MAGNOLIA SPRINGS ESTATES ADDITION

SUBDIVISION, RESUBDIVISION OF LOTS 6, 7, 12, & 13

APPLICATION NUMBER 14 DATE November 3, 2005
APPLICANT Magnolia Springs Estates Addition Subdivision, Resubdivision of Lots 6, 7, 12 and 13
REQUEST Subdivision

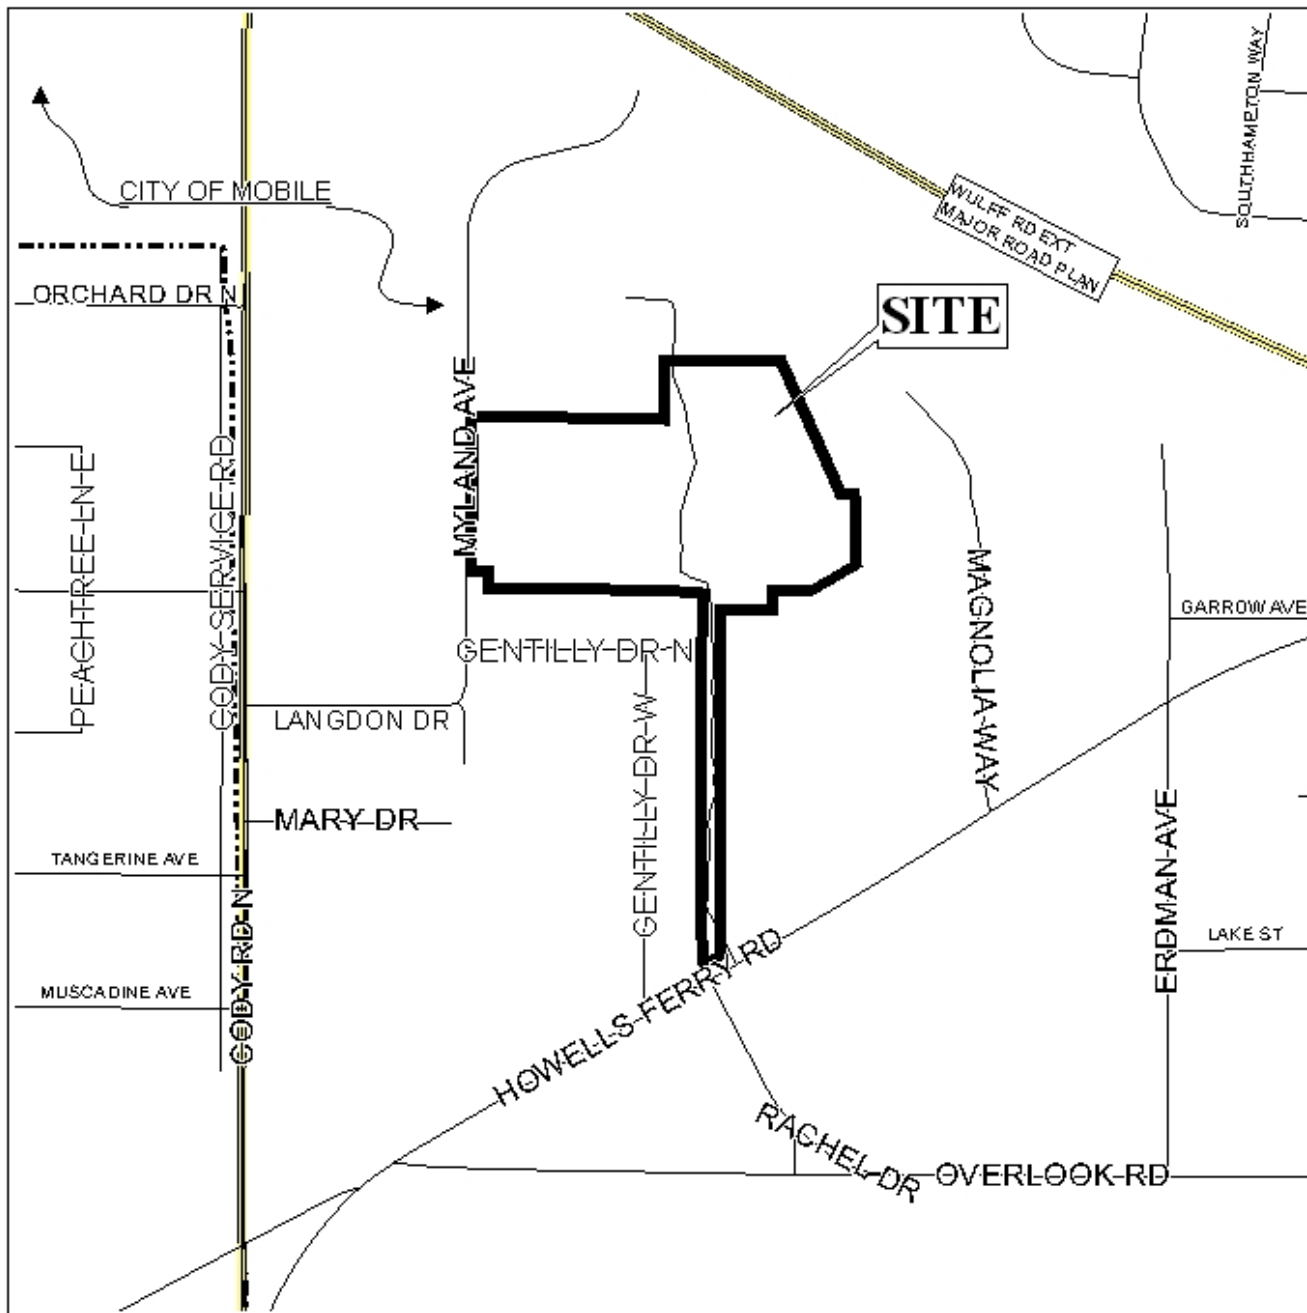
Engineering Comments: Must comply with all stormwater and flood control ordinances. Any work performed in the right of way will require a right of way permit.

Traffic Engineering Comments: Driveway number, sizes, location and design to be approved by Traffic Engineering and conform to AASHTO standards.

Urban Forestry Comments: Property to be developed in compliance with state and local laws that pertain to tree preservation and protection on both city and private properties (State Act 61-929 and City Code Chapters 57 and 64).

The original subdivision approval, in 1996, was similar to the present one, which simply proposes to realign interior lot lines, and will not significantly alter the lot configuration. However, a waiver of Section V.D.3 of the Subdivision (maximum depth) would still be required to address the flag-shaped nature of Lots 6-A and 7-A. The original subdivision conditions, which follow, should be maintained:

With a waiver of Section V.D.3 of the Subdivision Regulations, the plat will meet the minimum requirements of the Subdivision Regulations, and is recommended for Tentative Approval subject to the following conditions: 1) that a barricade be provided along the west property line, at the termination of Gentilly Drive North; 2) the provision of joint use driveways for Lots 6 and 7, with a minimum paved width of 18 feet each, and reflected on the final plat; 3) that Lot 11 be restricted to the driveway shared with Lot 12 (not included in this application); and 4) the provision of a 25-foot minimum building setback line along all street frontages.

DETAIL SITE PLAN

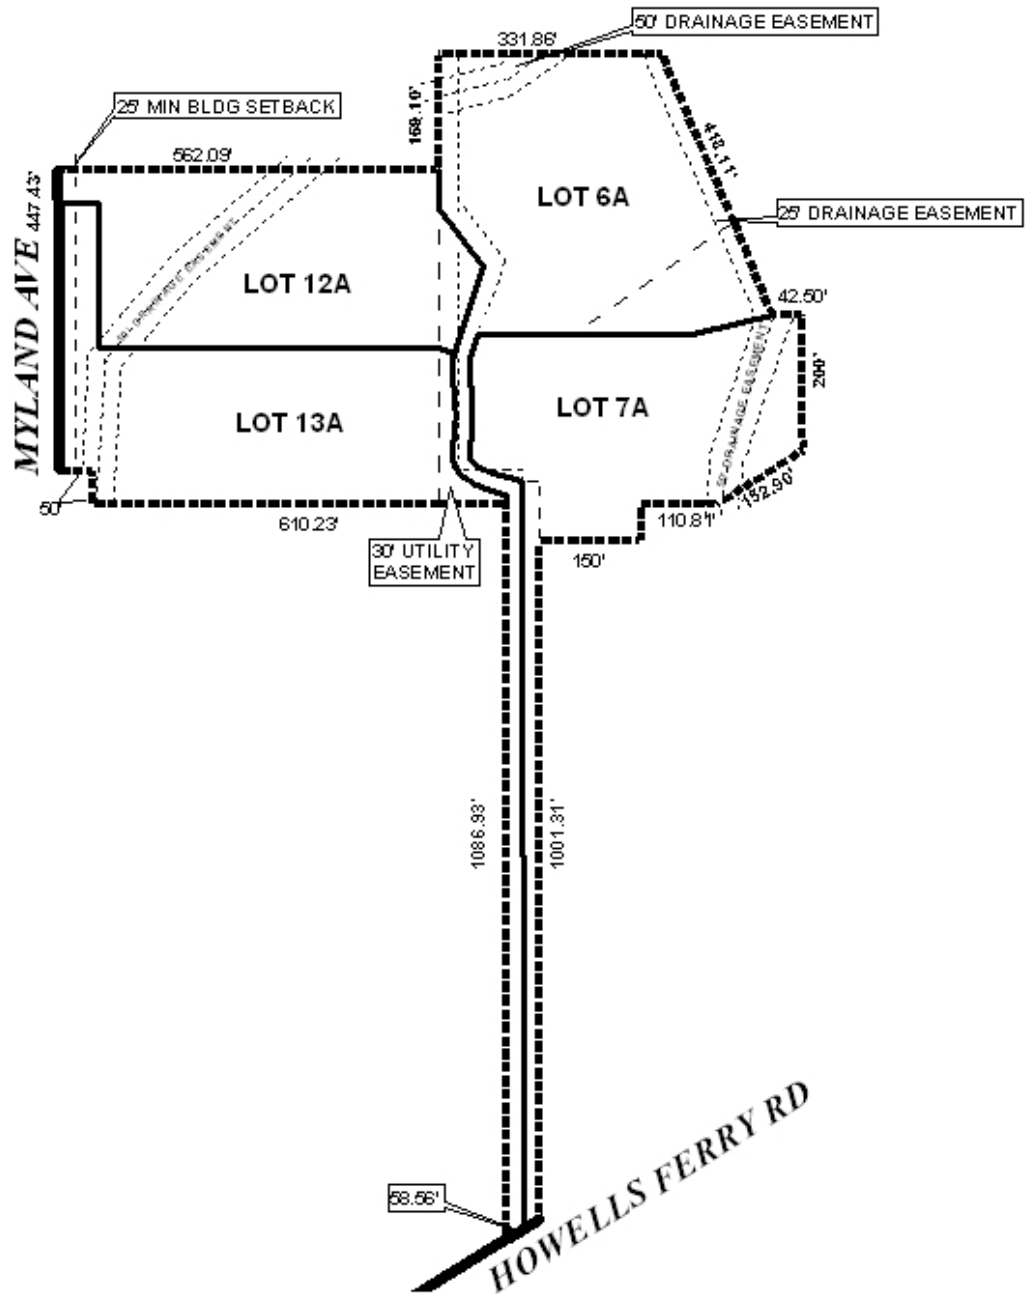
- 1) that a barricade be provided along the west property line, at the termination of Gentilly Drive North;*
- 2) the provision of joint use driveways for Lots 6 and 7, with a minimum paved width of 18 feet each, and reflected on the final plat;*
- 3) that Lot 11 be restricted to the driveway shared with Lot 12 (not included in this application); and*
- 4) the provision of a 25-foot minimum building setback line along all street frontages.*
